Applicant: Sarah Schweiger; City of Minnetonka
Consultant:
Project: Embankment Stabilization – Wing Lake
Location: Highland Road north of Excelsior Boulevard: Minnetonka
Rule(s): 2,5, 7 and 10
Reviewer: BCO

Permit #: 2019-09
Project Name: Highland Road Improvements – north of Excelsior Boulevard: Minnetonka
Approval Date: April 17, 2019

SHORELINE STABILIZATION PLAN
2019 MISCELLANEOUS DRAINAGE
HIGHLAND RD. / STA. 0+00 TO 16+00

RE: NMCWD Permit Application – City of Minnetonka Wing Lake Shoreline Maintenance

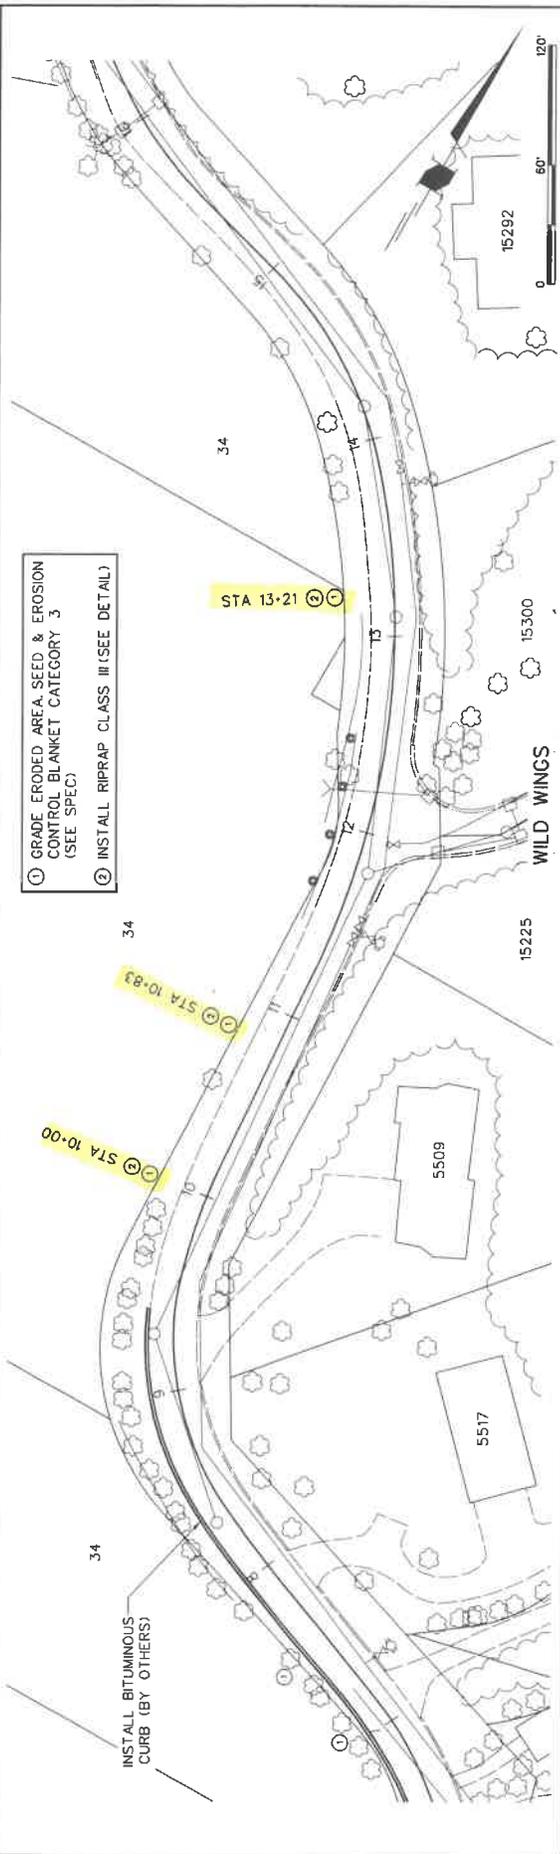
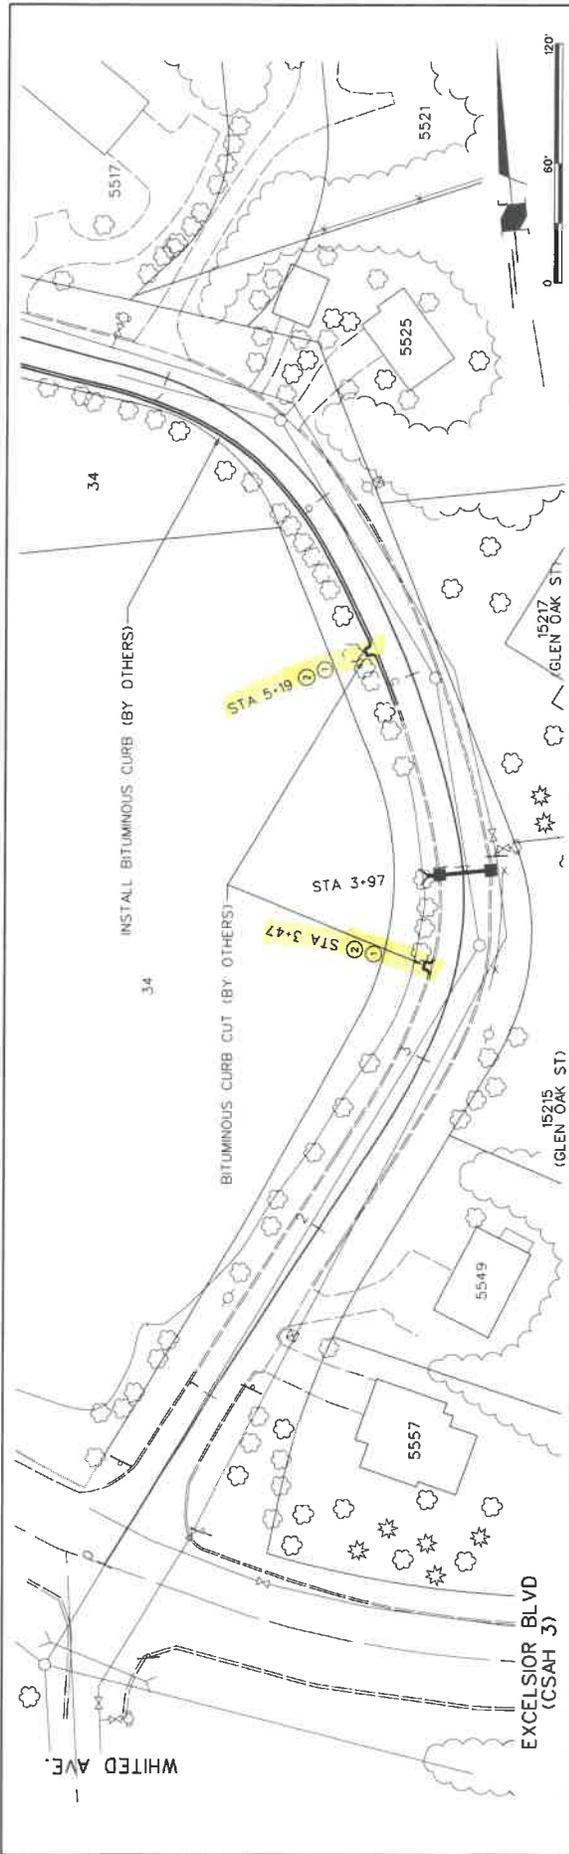
Both the existing and proposed stabilized slope in two locations will exceed the 3:1 slope. The maximum slope is 2.5:1 for distances of 5.5 and 5 feet respectively. A variance is requested for compliance with this section of the Rule.

The Plan proposed is to extend the slope of the stabilization to a depth of one foot below the normal level of the lake, 939.8 M.S.L. The O.H.W. of the lake is 940.3 M.S.L. At Station 3+97 the stabilized slope will extend 9 feet waterward, at Station 3+45 the stabilized slope will extend 8 feet waterward, at Station 5+18 the stabilized slope will extend 9.5 feet waterward and at Station 10+00 the stabilized slope will extend 6.7 feet waterward. At all five locations, the six foot requirement will be exceed. A variance is requested for compliance with this section of the Rule. Navigation on Wing Lake is not applicable.

A variance request for compliance with Rules 7.3.3 and 7.3.4 (attached) has been prepared by the City of Minnetonka to address Rules 10.1-10.4. The variance request is for compliance with the required maximum 3:1 finished slope (Rule 7.3.3) and no rip-rap or filter material may be placed more than 6 feet waterward of the O.H.W. (rule 7.3.4). The maximum stabilized slope at Station 13+20 will be 2.5:1 for a distance of 5 and at Station 10+85 will be 2.75:1 for a distance of 5.5 feet. The stabilized slopes at all five locations will extend a distance ranging from 6.7 feet to 9.5 feet waterward, exceeding the 6 foot requirement.

The applicant is requesting a variance from compliance with Rules 7.3.3 and 7.3.4 – the slope of the stabilization cannot be steeper than 3:1 and that rip-rap and sand filter cannot extend further than 6 feet wardward of the lakes O.H.W. The distances that the slope is greater than 3:1 is in two locations and is minimal (5 and 5.5 feet). The maximum distance that the stabilization will extend into the lake is 9 feet. The distance into the lake is based on the slope of the existing topography.

Two of the proposed stabilized sections will exceed the maximum slope of 3:1; Station 10+85 having a stabilized slope of 2.75:1 for a distance of 5.5 feet and Station 13+20 having a stabilized slope of 2.5:1 for a distance of 5 feet.

With the stabilized slopes provided, four sections will exceed the requirement that the placement of rip-rap or filter material can be no more than 6 feet waterward of the lakes O.H.W (940.3 M.S.L.); the outlet for the proposed catch basin at Station 3+97– 9 feet, Station 3+45 – 8 feet, Station 5+18 - 9.5 feet and Station 10+00 – 6.7 feet.
